Service Information Bulletin

Revised Information: Introduction of new Batteries providing Generator Power for DX-D 100 / DX-D 100 Wireless

DD+DIS013.13E
DD+DIS012.13E

DX-D 100 Wireless / DX-D 100

Figure 1

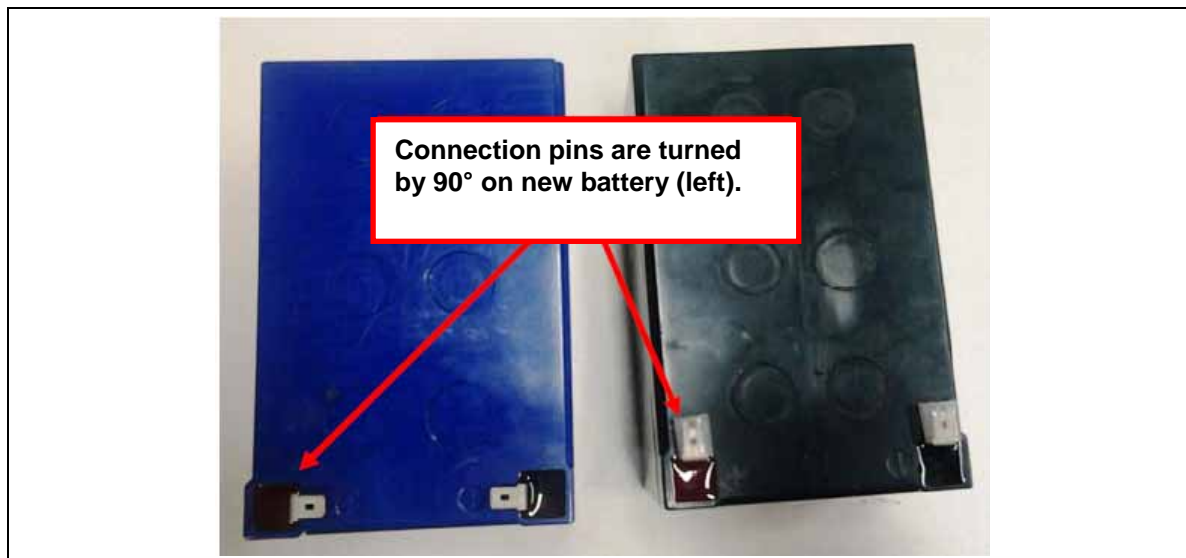
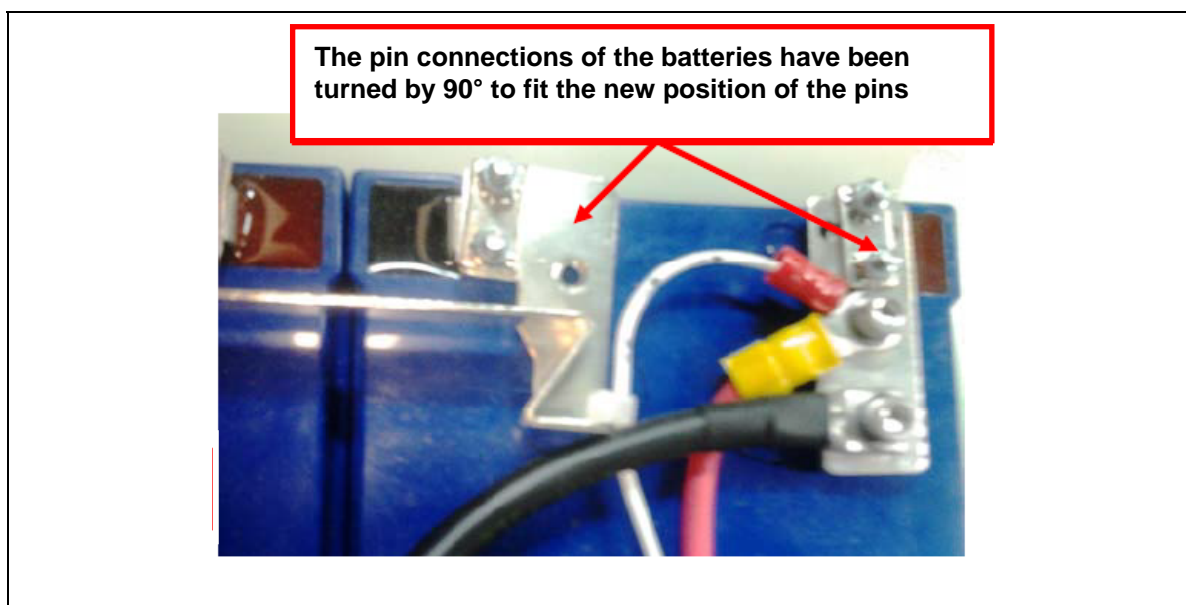
There have been some mechanical changes by the battery manufacturer. The new batteries are 3 mm taller and the connector pins have been turned by 90 degrees, see next figures.

After these changes, batteries in the DX-D 100 / DX-D 100 Wireless are not compatible with the current terminal connections, boxes and mechanical fixations.

As a result, batteries with the current design can not be replaced individually with new batteries anymore.

Figure 4

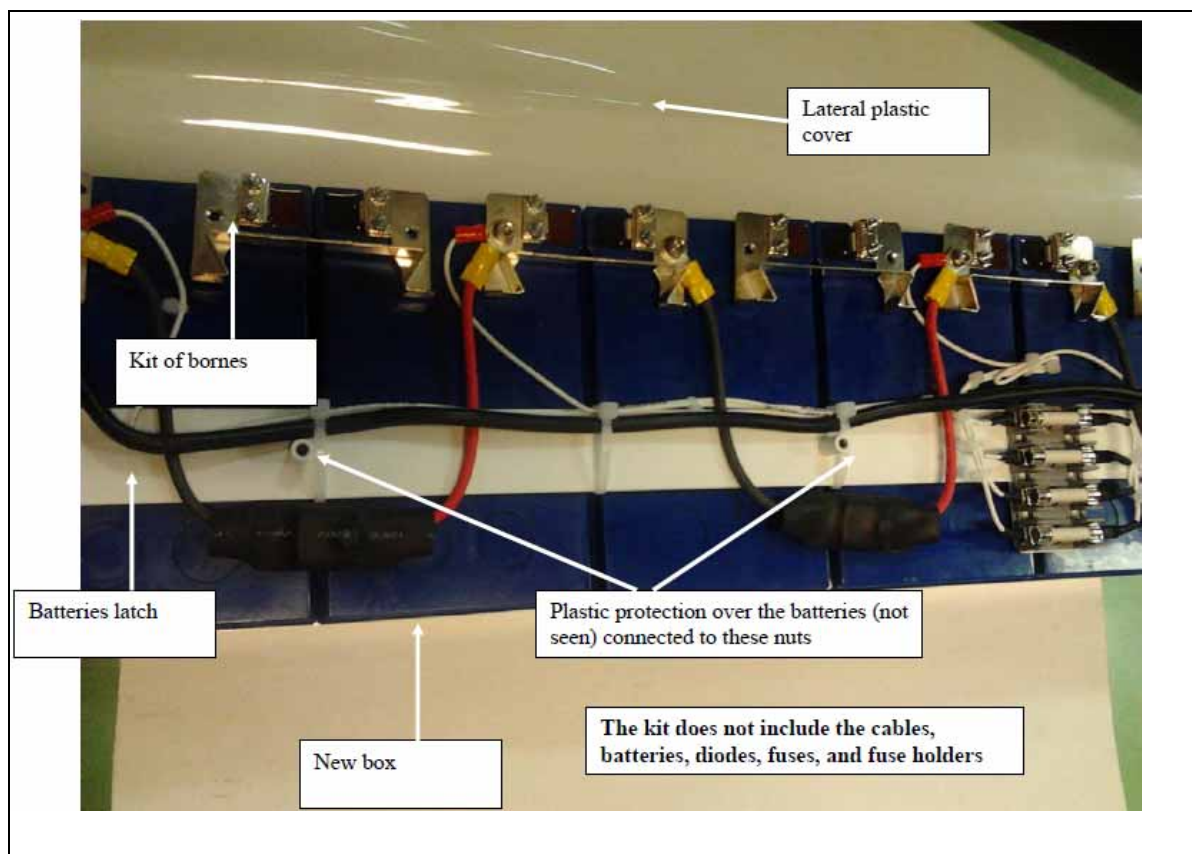
- SC+A521051-01 New individual 15Ah battery, only compatible with new mechanical parts.
- SC+A521050-01 Tray upgrade kit, consisting of new mechanical parts without batteries, cables, diodes, fuses, and fuse holder. (see figure 4).
- Individual batteries can also be ordered also from local suppliers: Battery Manufacturer CVS, Type EVH12150.

Figure 5

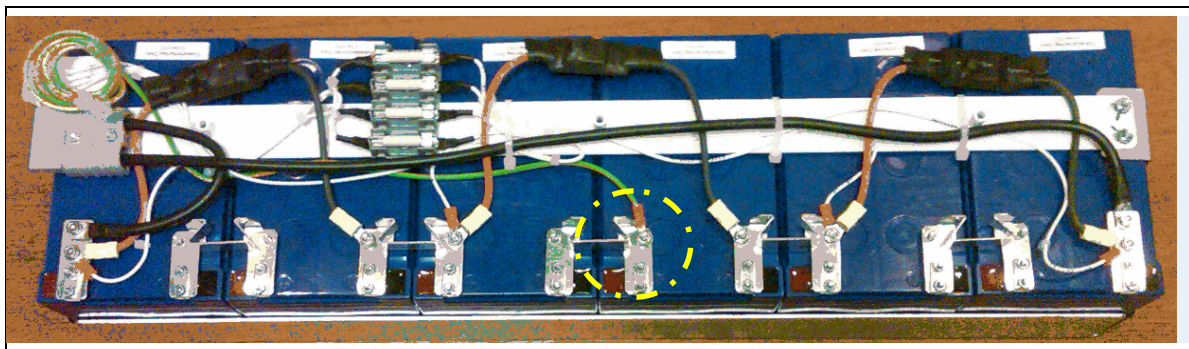
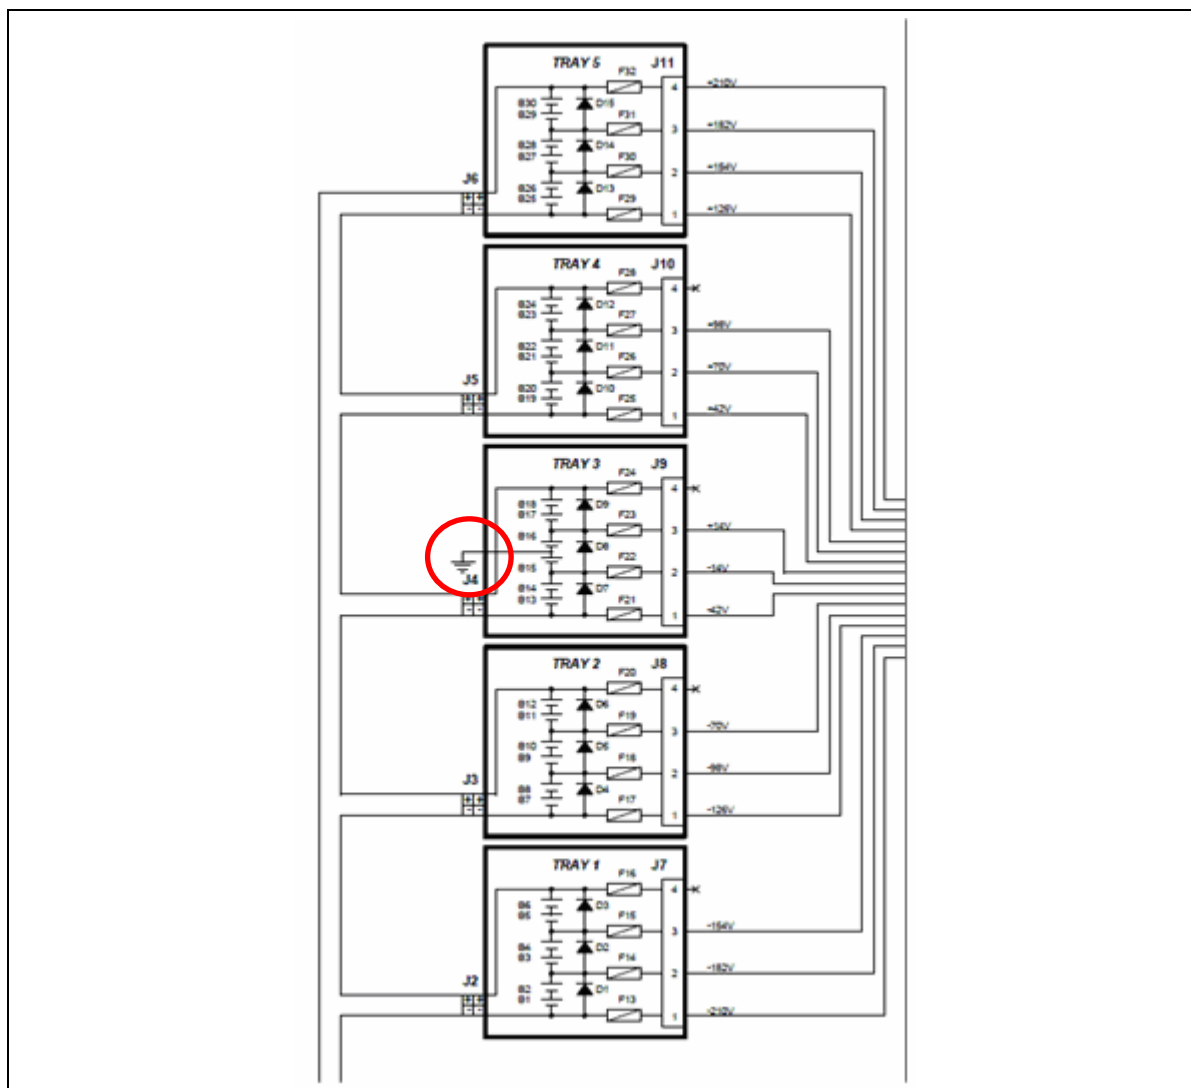
Complete trays SC+A521048-01 come already fully wired including a ground wire which is **only** required for **tray 3**. Do NOT connect the ground wires of any other battery tray!

For clarification, refer to figures 5 and 6 below. The wiring diagram in figure 6 shows how tray 3 is connected to the ground.

Remove the ground wire from trays 1, 2, 4, and 5 completely by removing the nut on the borne.
